# CITY PLANNING COMMISSION

1. Environmental Determination
2. Modification of a Special Permit to develop 712 apartment units in the Garden Apartment (R-2B)(PUD)) zone (Sec. 15-E)

**PROPOSAL:** The applicant is requesting the necessary entitlements to permit the development of a 712-unit apartment project.

**BACKGROUND INFORMATION:** This request involves the modification of a special permit to develop a 712-unit apartment complex in the Natomas Oaks Planned Unit Development.

# EXHIBIT A

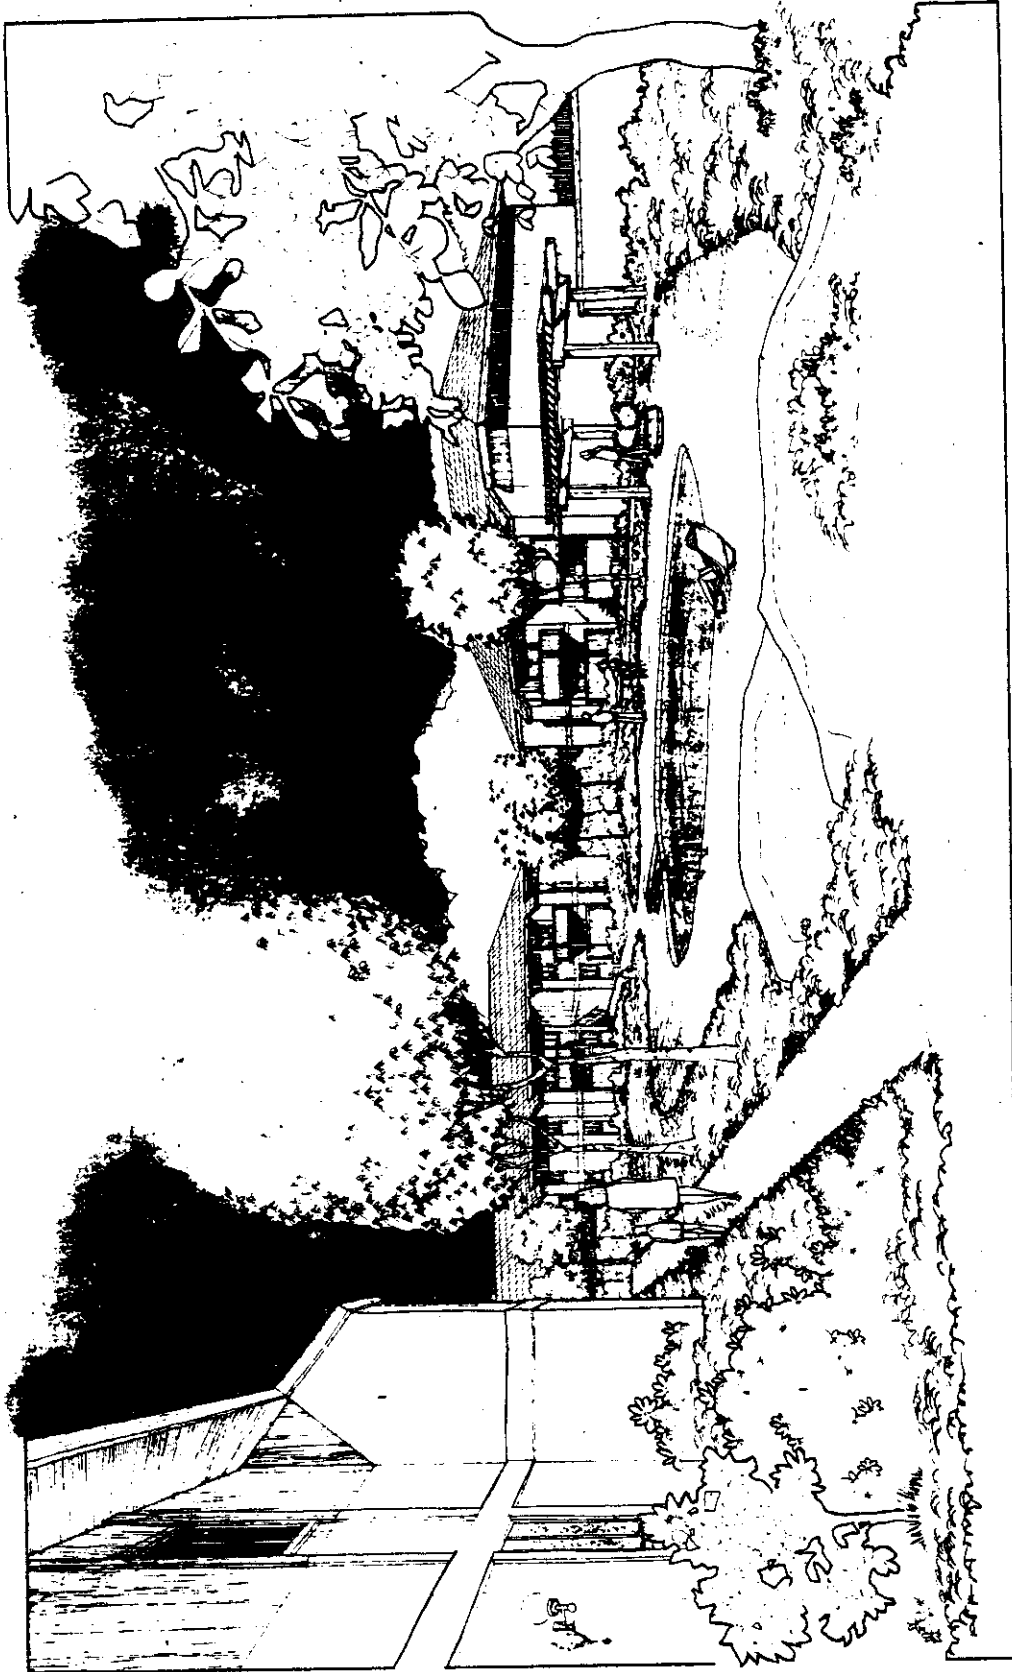
The 712 units approved for this site were to be located in one, two and three-story structures as indicated in the attached site plan (see Exhibit A). The three-story buildings are indicated by the diagonal lined footprints; the single story units are designated by cross hatched patterns, and the remaining units are two stories. Although this plan is the same as originally approved by the Commission, the three-story units were not reflected in the elevations. In addition, the applicant replaced the two-story structures at the main entrances of each phase with one-story structures.

The original site plan indicated two-story structures adjacent to the main entrances to each phase. This has been modified to provide a total of four one-story structures at these entrances.

- a. The applicant shall revise the site plan to provide for more convenient parking for those cluster of units indicated in Exhibit A. Revised plans which indicate this shall be submitted for the review and approval of the Planning Director prior to the issuance of building permits.

# EXHIBIT C

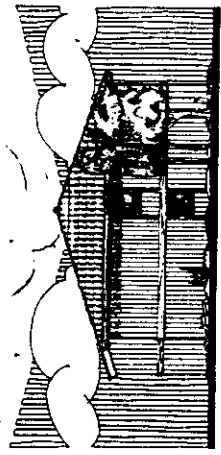
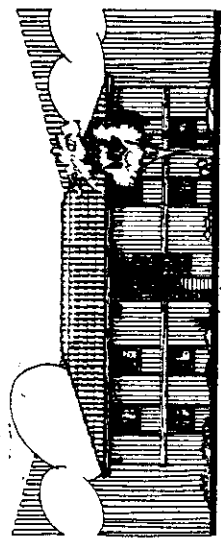
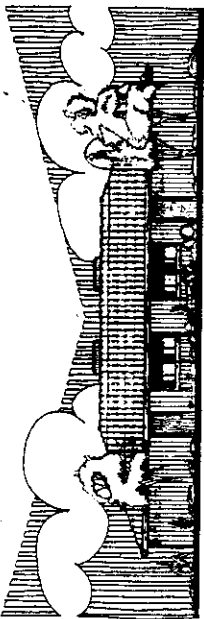
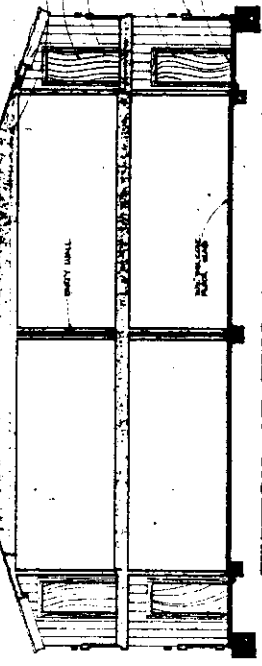
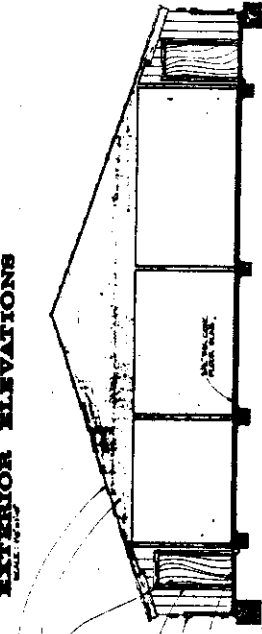
1. The proposed modification will not alter the density of the development of 21.9 units per acre or the number and size of the units originally approved by the Commission.
2. The height of the three-story structures will be 33 feet, which is below the maximum height limit of 35 feet in the Garden Apartment (R-2B) zone. The three-story buildings represent 19% of the total apartment development or 14 of the total 75 structures. There will be 57 two-story structures and four single-story buildings in the proposed apartment project.
